## PLANNING COMMISSION MEETING STAFF REPORT

**NAME OF PROJECT:** Whispering Creek Estates

**AGENDA ITEM:** Preliminary Approval

**Subject: Whispering Creek Estates – Preliminary Review**

**WETLAND/FLOOD MAP**

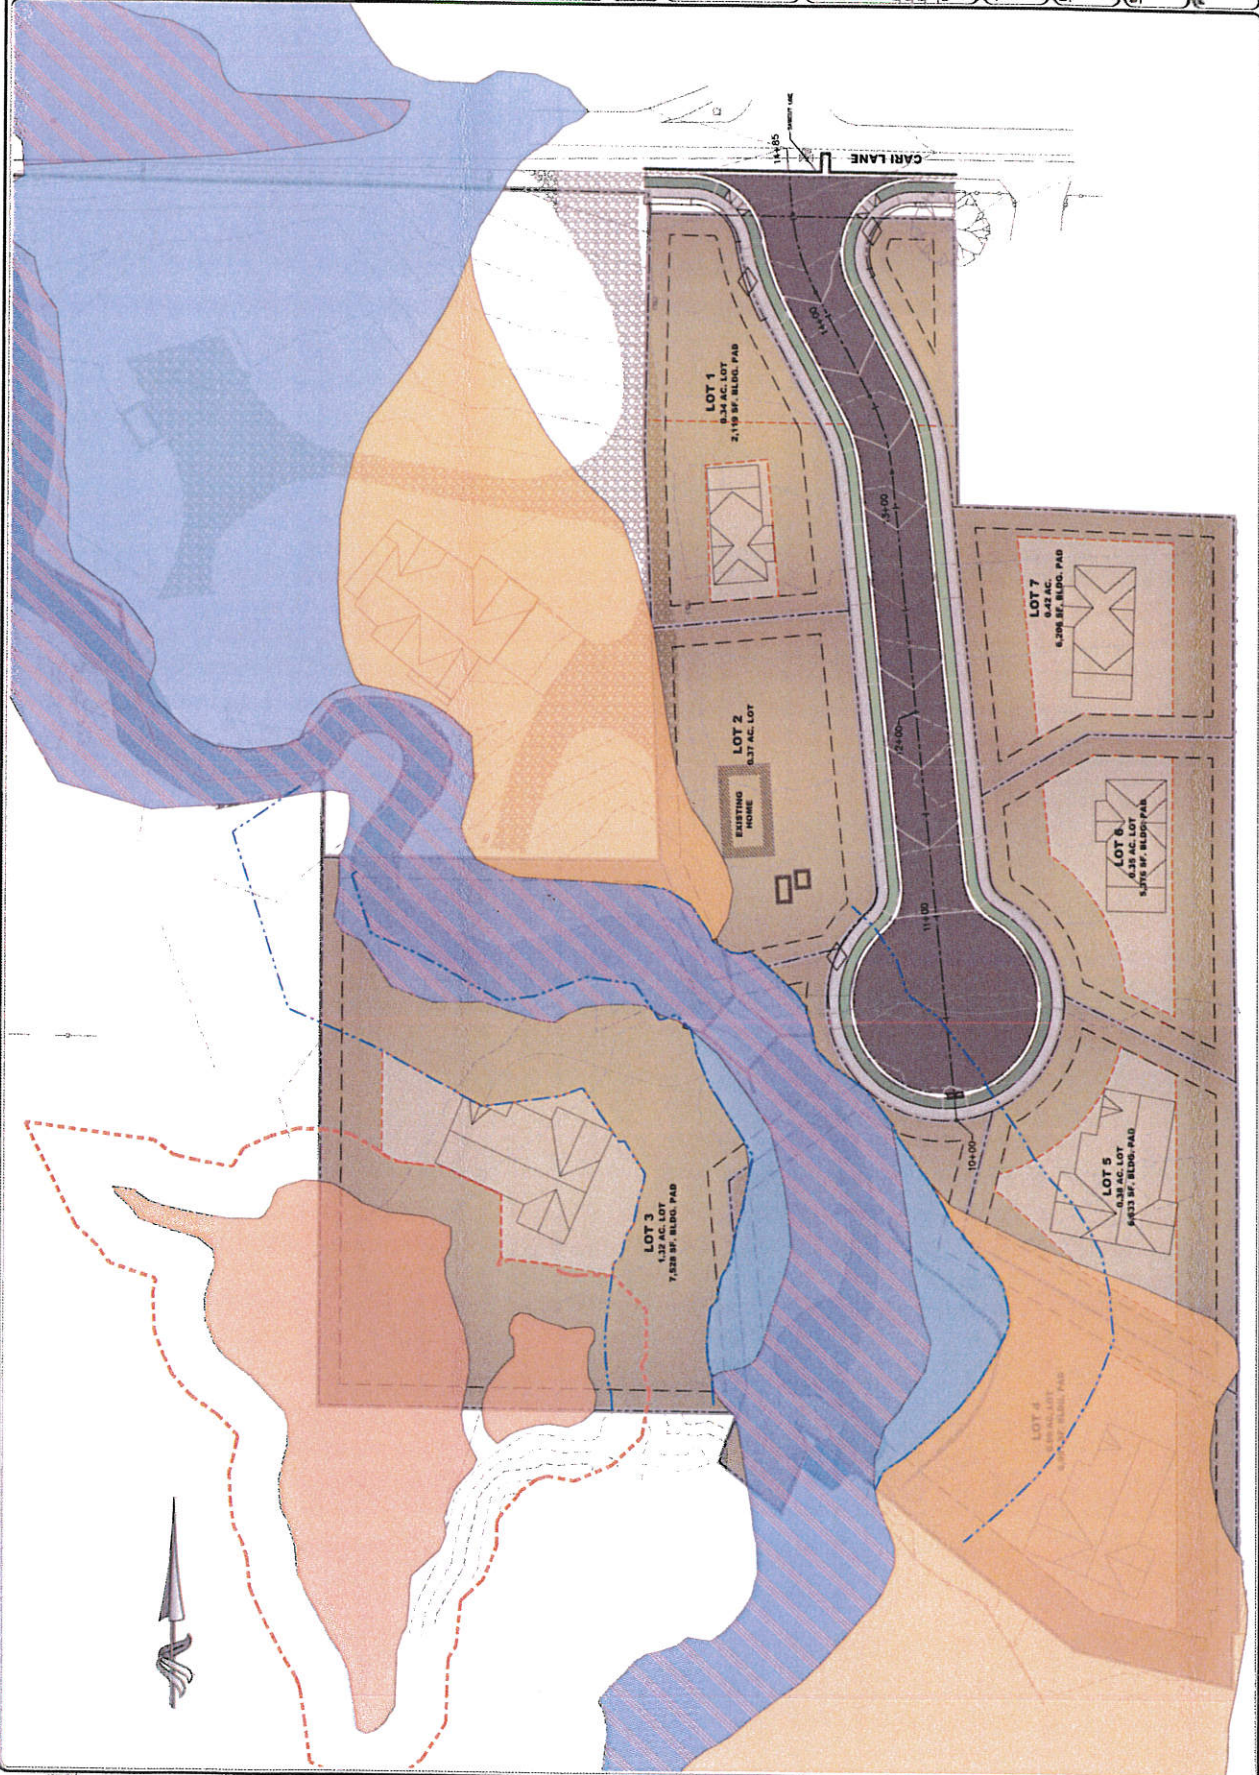
*Sensitive lands* – There are wetlands and FEMA floodplain areas in the proposed subdivision area. A wetland map has been submitted to the City along with a wetlands delineation and inventory investigation (please see attached). The code requires a 25' buffer area for any structures and disturbance from any delineated wetlands. The buffer area has been included in the plans. The study has been submitted to the City and to the US Army Corp. of Engineers for their review and approval. The City has not received information that the delineation report has been approved by the US Army Corp.

The proposal includes FEMA flood zone areas including Zone AE (1% annual flood) which requires a 50' setback. The 50' setback has been marked on the plans from Zone AE. No structures may be located in this area, but the setback area may be filled and landscaped. Landscaping is allowed in the FEMA flood area, but nothing is allowed that will modify the FEMA flood zone, this includes placing rocks or fill of any type in this area that impacts the functionality of the floodplain. There is area in the subdivision that is designated Zone X which is area of the 500-year flood (0.2%

annual chance flood) and is considered a low risk area but there is flooding potential. Flood insurance is not federally required but it is recommended in the Zone X area. A note should be placed on the plat that advises future owners of lots 4 and a small section of lots 2 and 5 (though the dwelling may be located completely outside of the zone on lots 2 and 5) of the potential flood hazard. To meet the 50' the building pads for lots 4 and 5 must be adjusted.

- A stream alteration permit should be obtained prior to application for final approval.
- A wetland delineation has been submitted to the Army Corp. The Corp should accept the delineation prior to approval.
- The wet land and flood plains with their required setbacks on plans should be shown on the plat map.

- The 25 foot setbacks shall be maintain around all delineated wet lands as approved by the Corp.
- The 50' setbacks shall be maintained around all FEMA flood Zones.

1. A wetlands study must be approved by the Army Corps of Engineers before the item is reviewed for preliminary approval by the City Council.
2. A stream alteration permit must be approved before final approval is granted by the City Council.
3. A note shall be placed on the plat that advises future owners of lots 2, 4 and 5 of the potential flood hazards.
4. The developer must build the driveway crossing in lot 3 as part of the subdivision infrastructure.
5. The building envelope for lot 5 must be updated so that no part of the building envelope is within 50' of the FEMA Zone AE floodplain.
